## SERVICE BULLETIN

**NUMBER:** SB 500-71-001, REV A  
**MODEL:** ECLIPSE EA500  
**SUBJECT:** STARTER GENERATOR POWER/GROUND GROMMET REWORK

**Starter Generator Cable Grommet Apron Installation  
Figure 1**

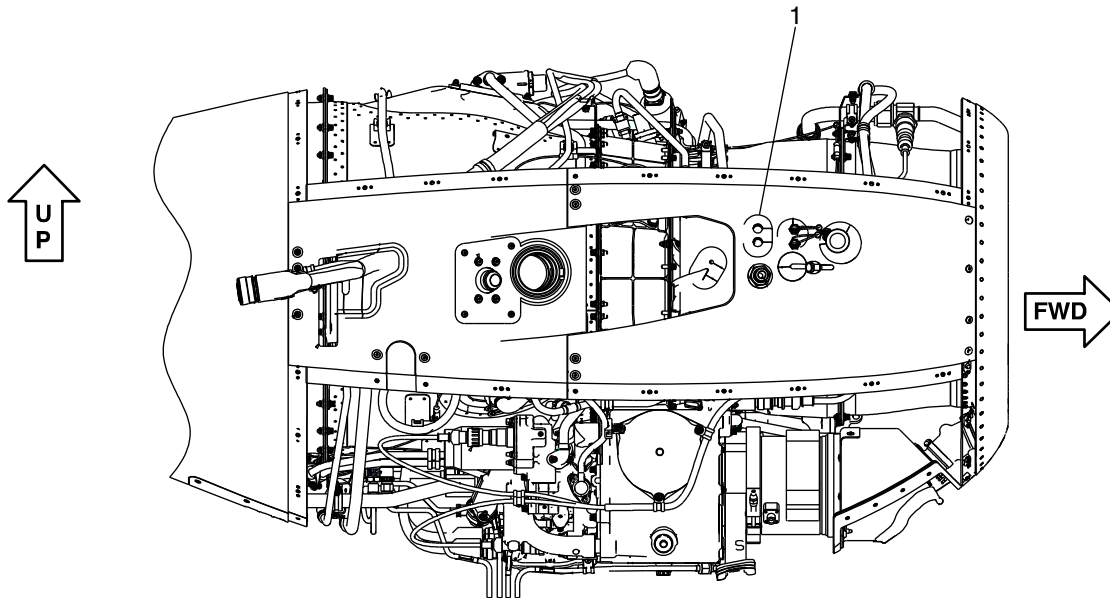
- (1) Remove and discard starter generator cable grommet P/N 71-117748-2001 (1, [Figure 1](#)) by carefully cleaning and removing the Fast block 100 from the apron.

- (14) Install starter generator cable grommet P/N 71-117748-2001 into apron on both left and right sides. If necessary, lubricate the edges of grommet with isopropyl alcohol to facilitate ease of installation.

- (18) Apply Fast Block 100 sealant to starter generator cable grommet P/N 71-117748-2001 at the apron with a scraper, sealing all openings. Make sure to apply sealant on both sides (inside and outside) of the apron.

**Cable Grommet Fuselage Installation (Left Pylon Shown, Right Pylon Similar)  
Figure 2**

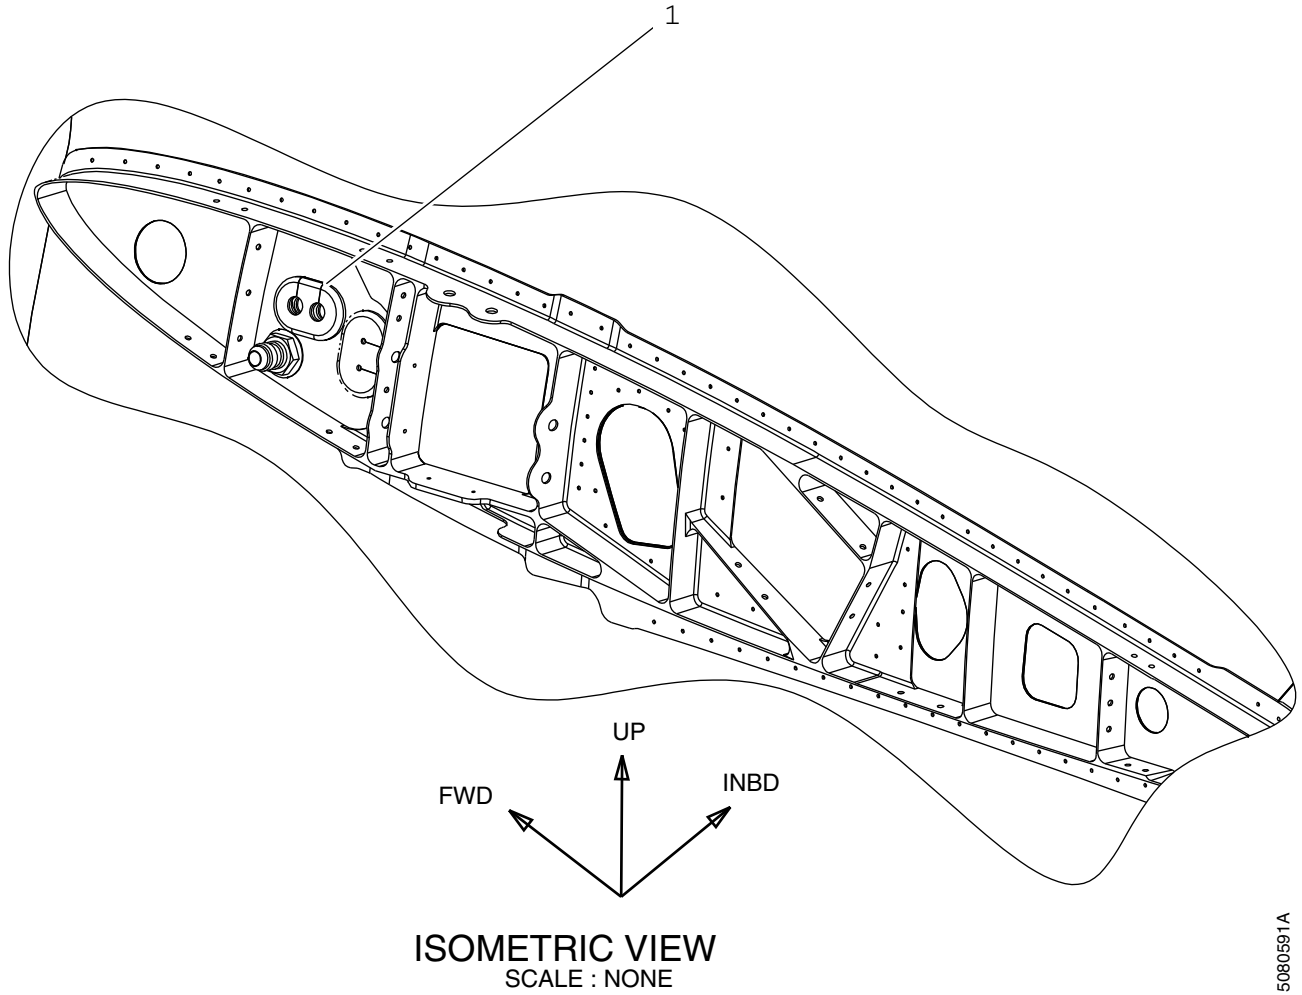
- (2) Remove and discard starter generator cable grommet P/N 71-118251-2001 (1, [Figure 2](#)) by carefully cleaning and removing the DC-732 sealant between the grommet and aircraft skin.

- (13) Install starter generator cable grommet P/N 71-117748-2001 into enlarged fuselage openings on both left and right sides. If necessary, lubricate the edges of grommet with isopropyl alcohol to facilitate ease of installation.

- (17) Apply Dow Corning (DC-732) all around the edges of starter generator cable grommet P/N 71-117748-2001 at the fuselage skin, sealing all openings. Make sure to remove all excess adhesive from the fuselage skin.

**Aft Fuselage Skin Modification  
Figure 3**

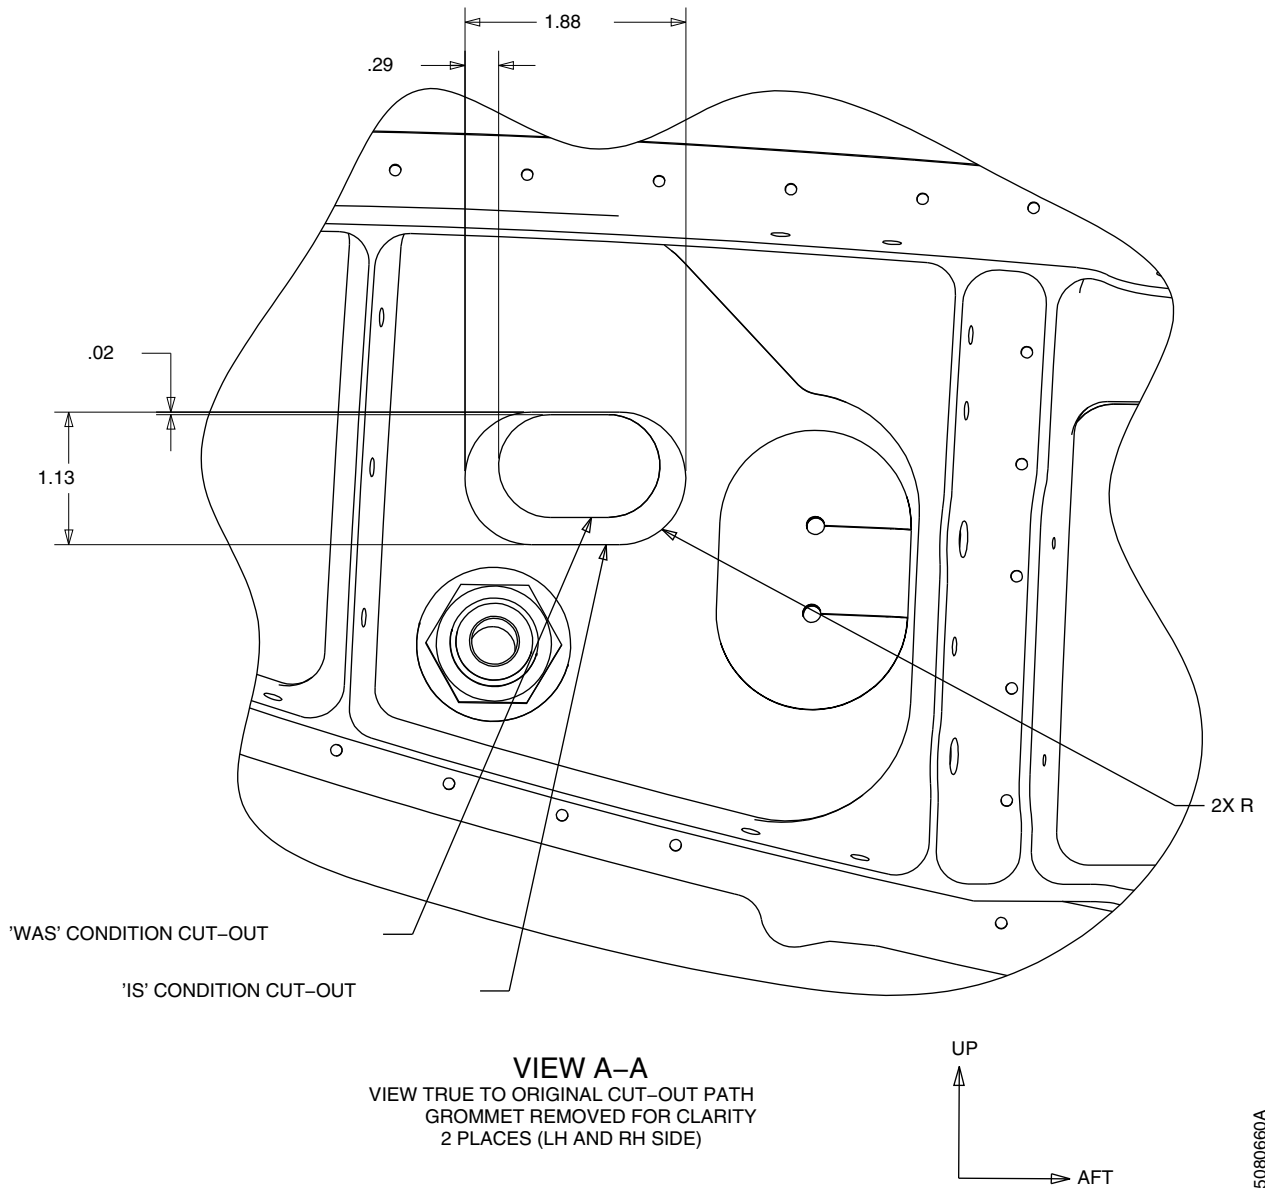
- (5) Remove all sealant or adhesive from aircraft skin and apron in area where grommets were removed with a non-metallic scraper.
- (6) Enlarge the aircraft skin opening that accepts the starter generator cable-to-aircraft grommet. Refer to [Figure 3](#).

- (7) Remove all metal shavings from reworked areas in both the pylon and inside the maintenance bay.
- (8) Break sharp edges to 0.005 to 0.015 inch and maintain 125RHR or better surface finish on the enlarged penetration.
